**Subject: PCN#09A-19 Product Change Notification Alternate Additional Assembly / Test Supplier Qualification for Select Lattice Products**

Lattice is providing this Product Change Notification (PCN) of our intent of using Advanced Semiconductor Engineering Inc., Kaohsiung (ASEK) as alternate assembly and test source for select Lattice Semiconductor products. Unless otherwise noted, there is no change in form, fit or function of the affected products.

M4A5-128/64-xYNx, PQFP, 14 X 20mm, 100 leads

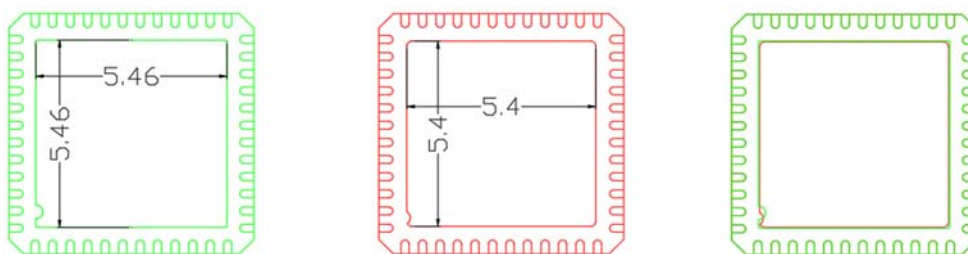
- Slight movement of pin 1 dot mark

Symbol	Lattice POD			ASEK POD		
	Min	Nom	Max	Min	Nom	Max
A	-	-	3.40	-	-	3.40
A1	0.25	-	0.50	0.25	-	0.50
A2	2.50	2.70	2.90	2.50	2.72	2.90
D		23.20 BSC			23.20 BSC	
D1		20.00 BSC			20 BSC	
E		17.20 BSC			17.20 BSC	
E1		14.00 BSC			14 BSC	
L	0.73	0.88	1.03	0.73	0.88	1.03
c	0.11	-	0.23	0.11	0.152	0.23

**SIH9535CTUC, TQFP, 14 X 14mm, 100 leads**

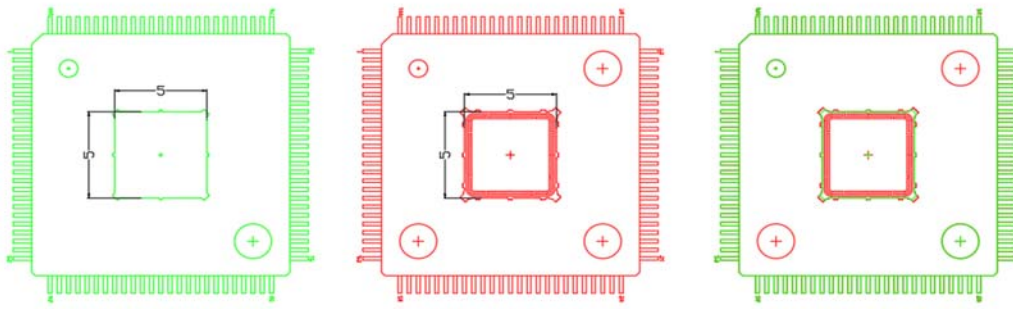
- 2 additional ejector pin marks
- Minor difference on exposed pad periphery

Item	Description	Lattice POD			ASEK POD		
		Min	Typ	Max	Min	Typ	Max
A	Thickness	---	---	1.20	1.00	1.10	1.20
A1	Stand-Off	0.05	---	0.15	0.05	0.10	0.15
A2	Body Thickness	0.95	1.00	1.05	0.95	1.00	1.05
D	Footprint	16.00 BSC			15.90	16.00	16.10
D1	Body size	14.00 BSC			13.80	14.00	14.20
E	Footprint	16.00 BSC			15.90	16.00	16.10
E1	Body size	14.00 BSC			13.80	14.00	14.20
L	Lead foot length	0.45	0.60	0.75	0.45	0.60	0.75
L1	Total lead length	1.00 REF			1.00 REF		
R1	Lead radius, inside	0.08	---	---	0.08	---	---
R2	Lead radius, outside	0.08	---	0.20	0.08	---	0.20
S	Lead horizontal run	0.20	---	---	0.20	---	---
Θ	---	0°	3.5°	7°	0°	3.5°	7°
Θ1	---	0°	---	---	0°	---	---
Θ2	---	11°	12°	13°	11°	12°	13°
Θ3	---	11°	12°	13°	11°	12°	13°

**SIH7172CLU LQFP, 14 X 20mm, 128 leads**

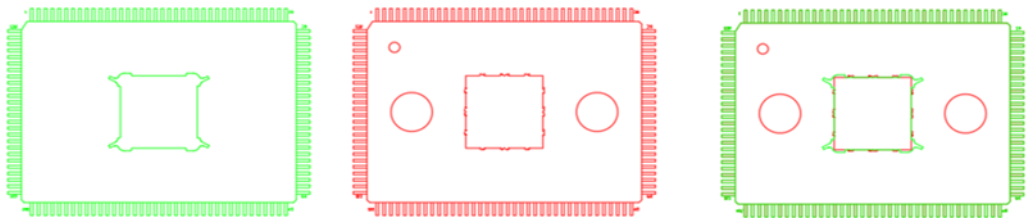
- Slight differences on exposed pad periphery
- Two additional ejector pin marks and pin 1 dot (bottom) on ASEK version

Item	Description	Min	Typ	Max	Min	Typ	Max
A	Thickness	---	---	1.60	---	---	1.60
A1	Stand-off	0.05	---	0.15	0.05	---	0.15
A2	Body thickness	1.35	1.4	1.45	1.35	1.4	1.45
D1	Body size	20 BSC			20 BSC		
E1	Body size	14 BSC			14 BSC		
F1	Footprint	16 BSC			16 BSC		
G1	Footprint	22 BSC			22 BSC		
L1	Lead length	1.00 REF			1.00 REF		
c	Lead thickness	0.09	---	0.2	0.09	0.127	0.2

**iCE40UP5K-SG48**, Sawn QFN, 7 X 7mm, 48 leads

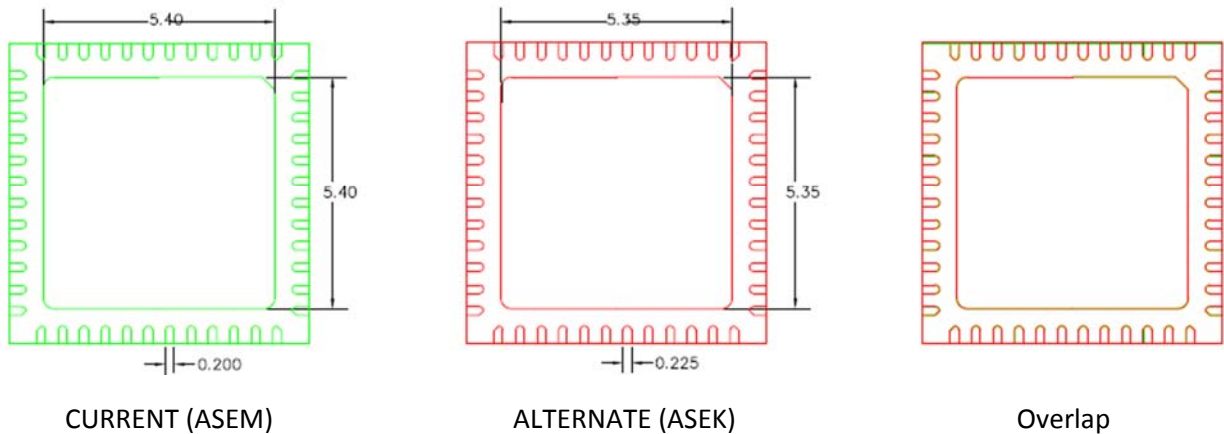
The iCE40UP5K-SG48 (48 QFN package) has a pad width change.

- Minor lead width difference
- Slight difference on exposed pad dimension

Symbol	Lattice POD			ASEK POD		
	Min	Nom	Max	Min	Nom	Max
A	0.80	0.90	1.00	0.80	0.90	1.00
A1	0.00	0.02	0.05	0.00	0.02	0.05
A3	0.2 REF			0.2 REF		
D	7.0 BSC			6.9	7.0	7.1
D2	5.30	5.40	5.50	5.20	5.35	5.50
E	7.0 BSC			6.9	7.0	7.1
E2	5.30	5.40	5.50	5.20	5.35	5.50
b	0.15	0.20	0.25	0.15	0.225	0.30
e	0.50 BSC			0.50 BSC		
L	0.35	0.40	0.45	0.35	0.40	0.45
